STATE OF MAINE
DEPARTMENT OF TRANSPORTATION
16 STATE HOUSE STATION
AUGUSTA, MAINE 04333-0016

November 18, 2022
Subject: Bridge Rehabilitation
State WIN: 021751.01
Location: **Boothbay Harbor & Southport
Amendment No. 5**

END STOP DETAILS

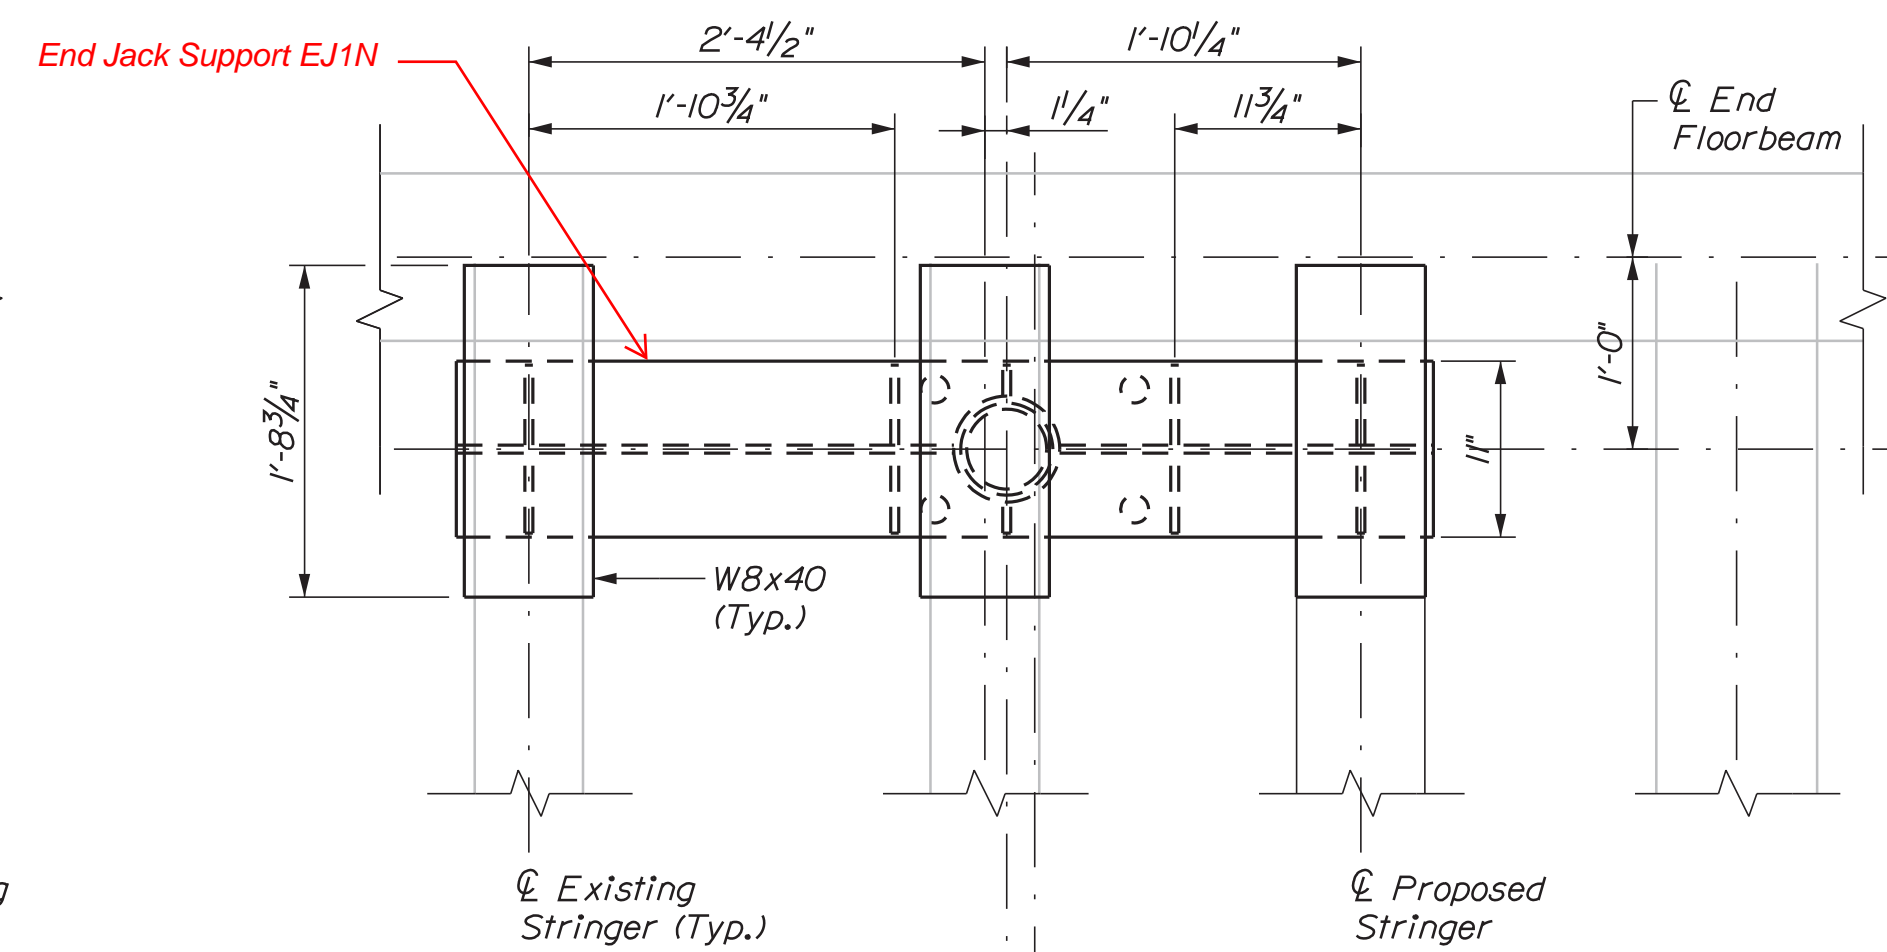
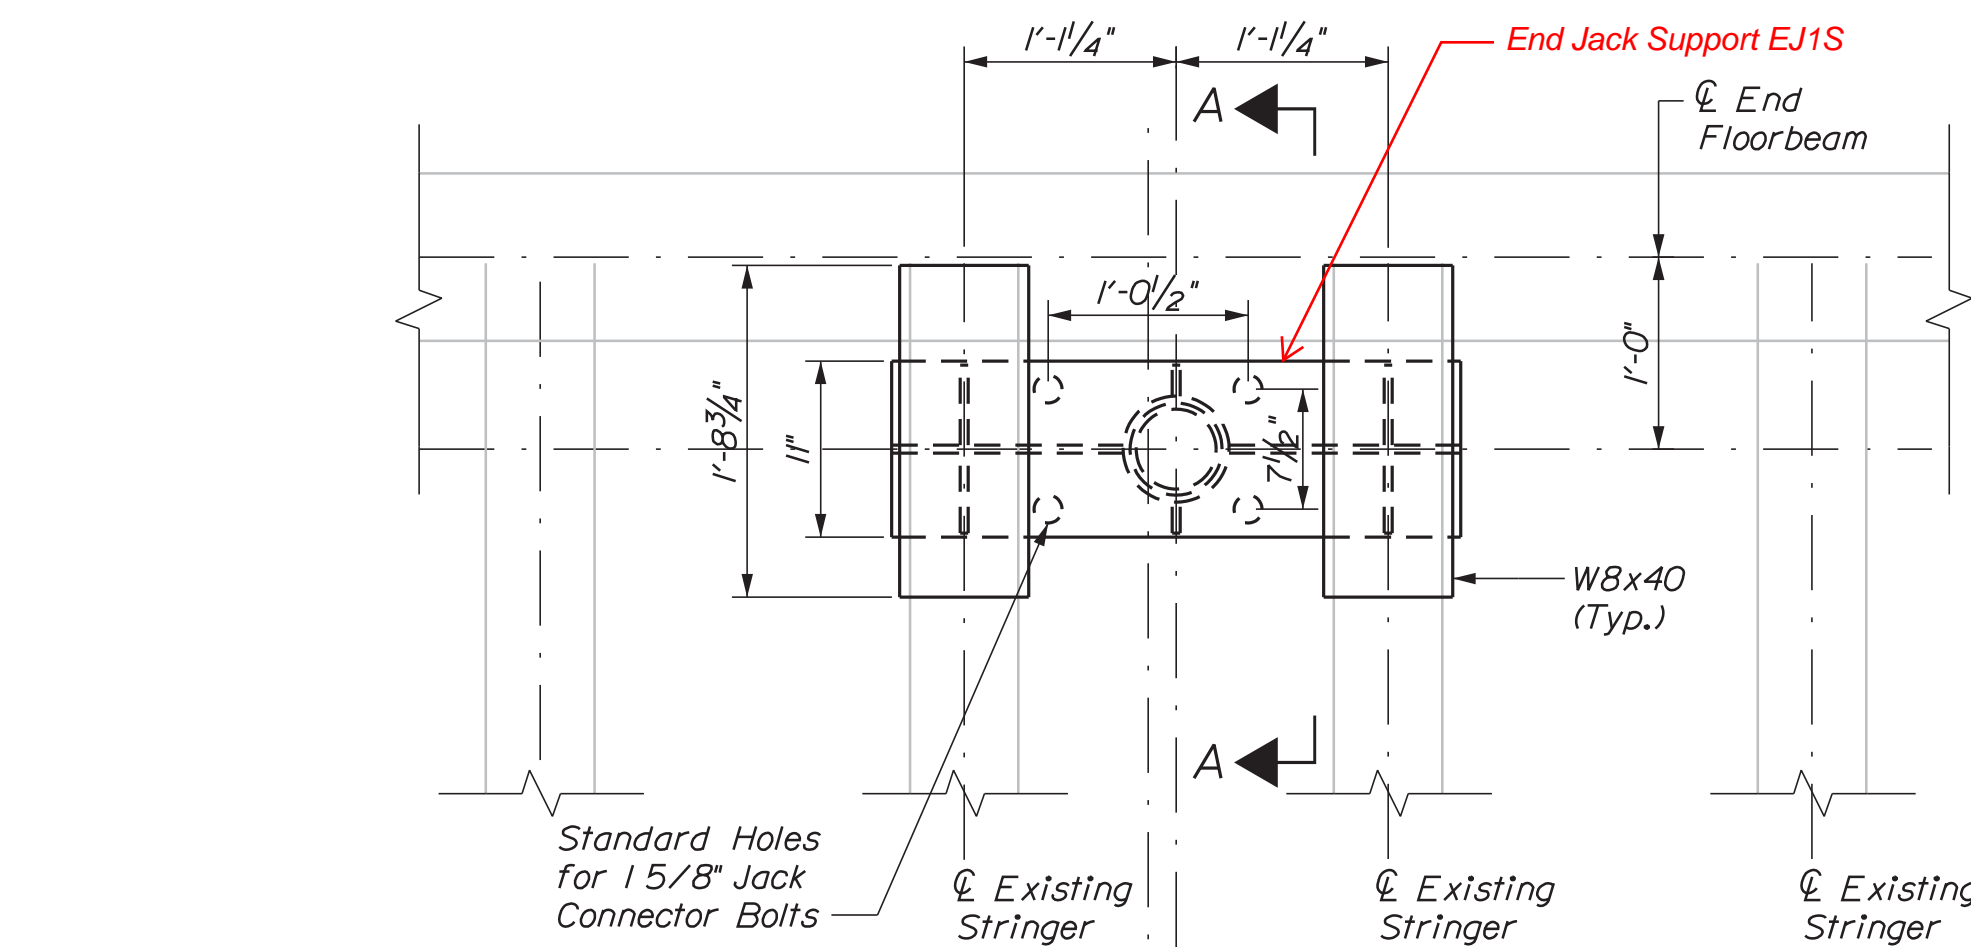
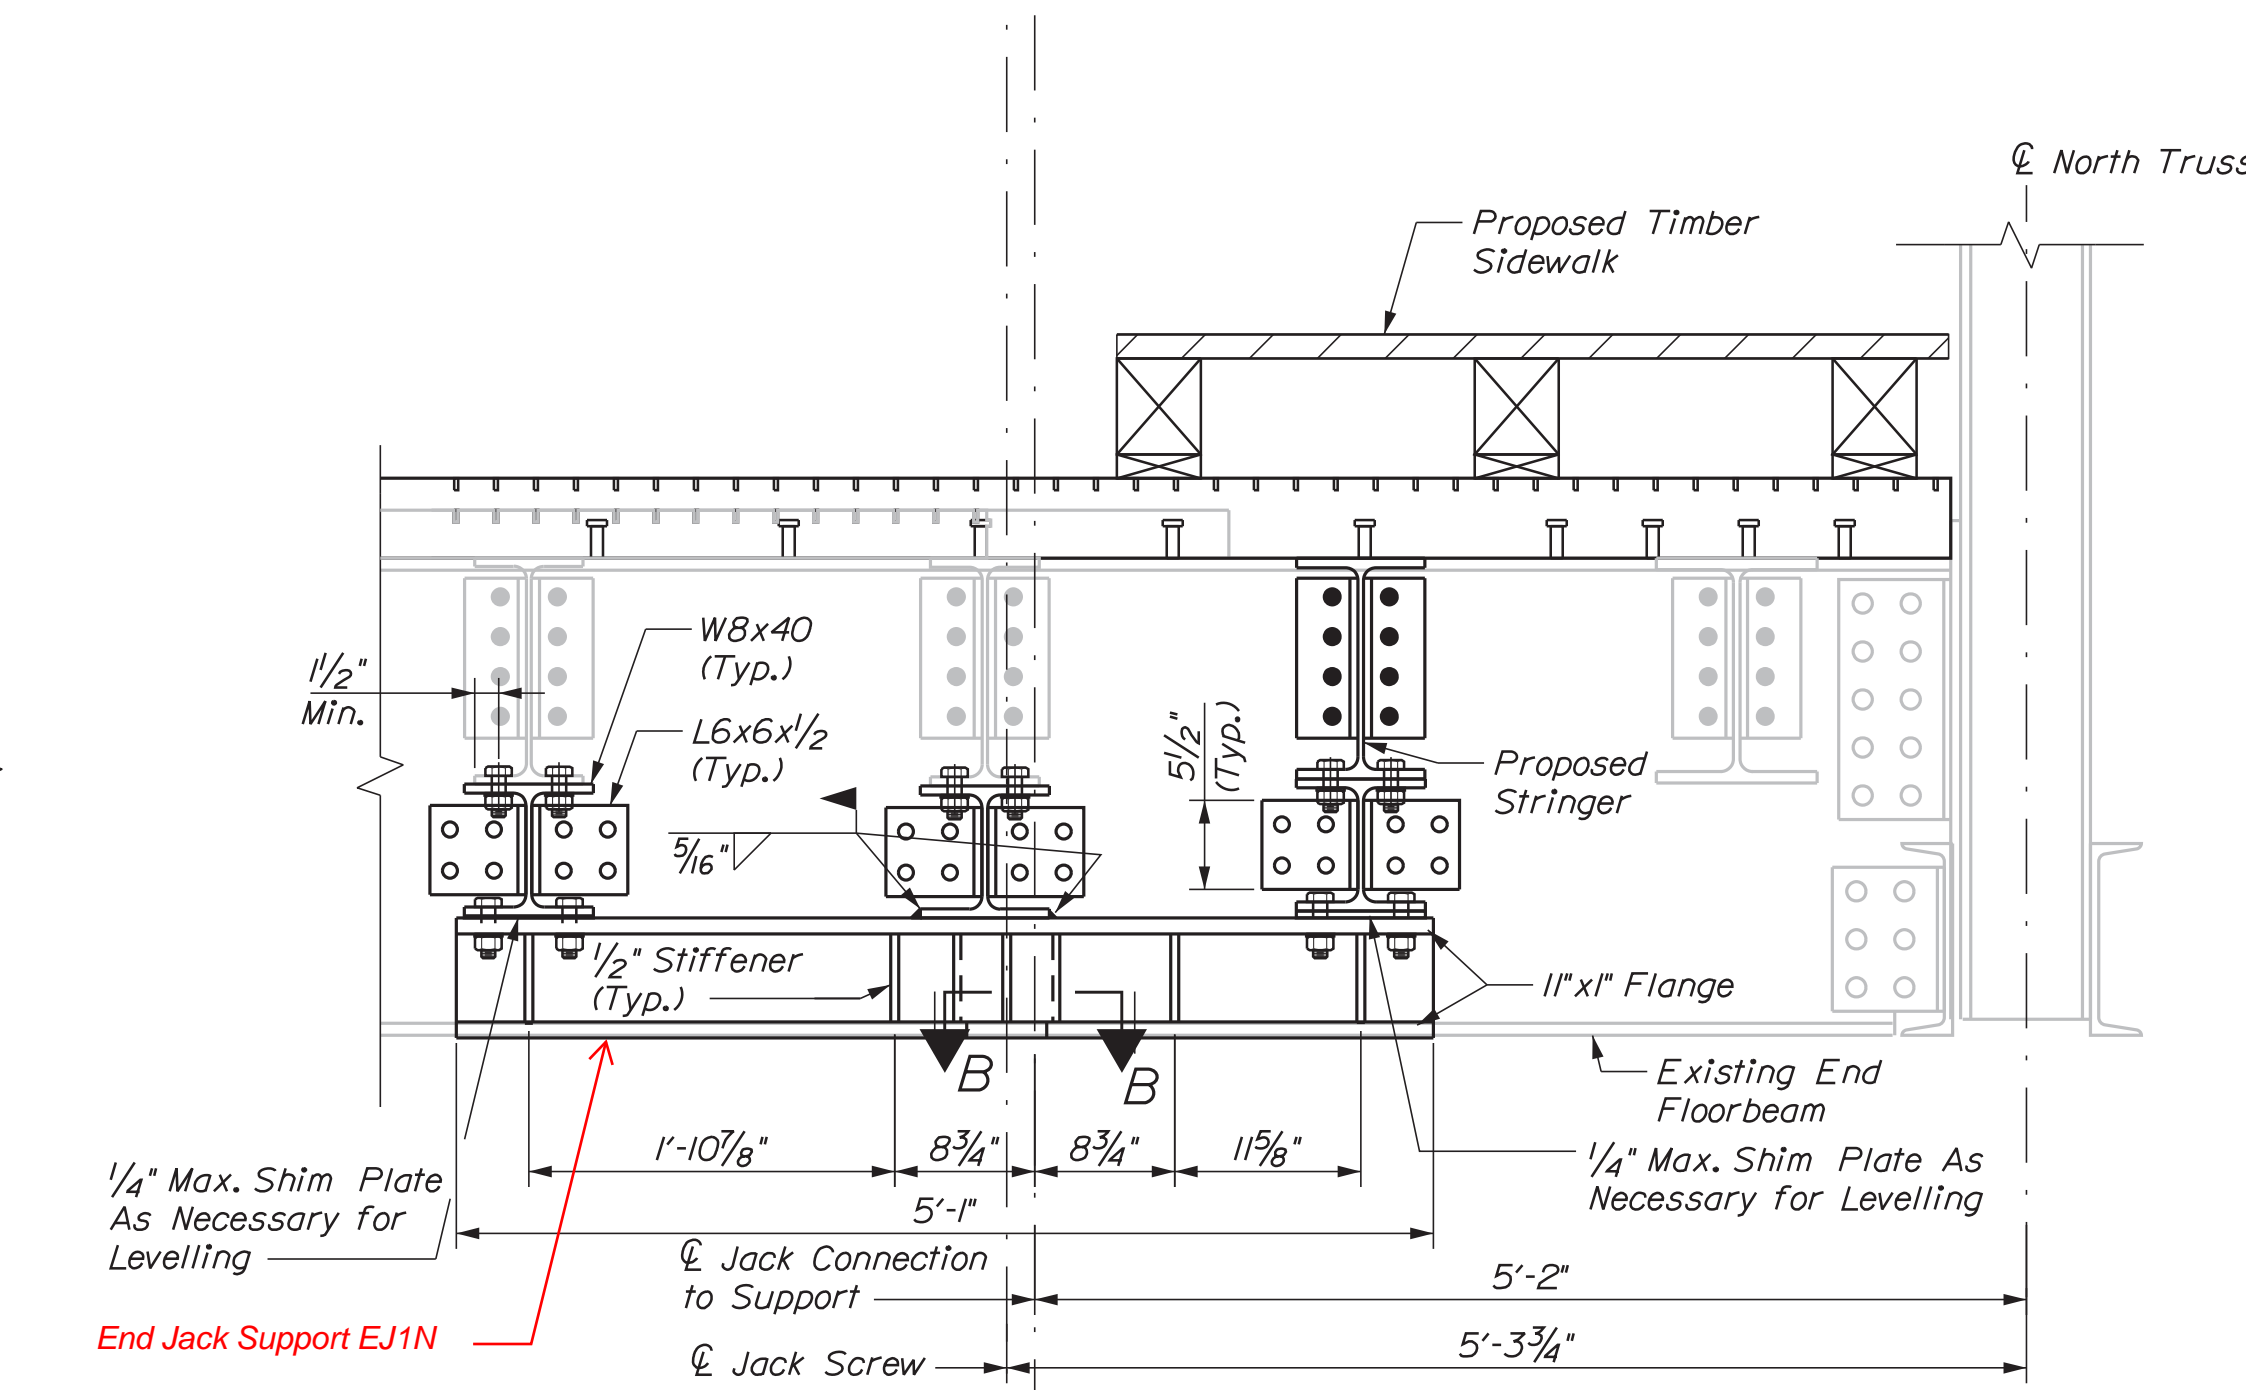
Question: Please refer to drawing M11 Elevation, the call out “End Stop (See note 8)” does not appear to be correct. Please clarify.

Response: Refer to drawing M11 Rev. 1 on which the End Jack callouts and Note 8 were revised. Sheet 32 of 48 has been updated to reflect these changes.
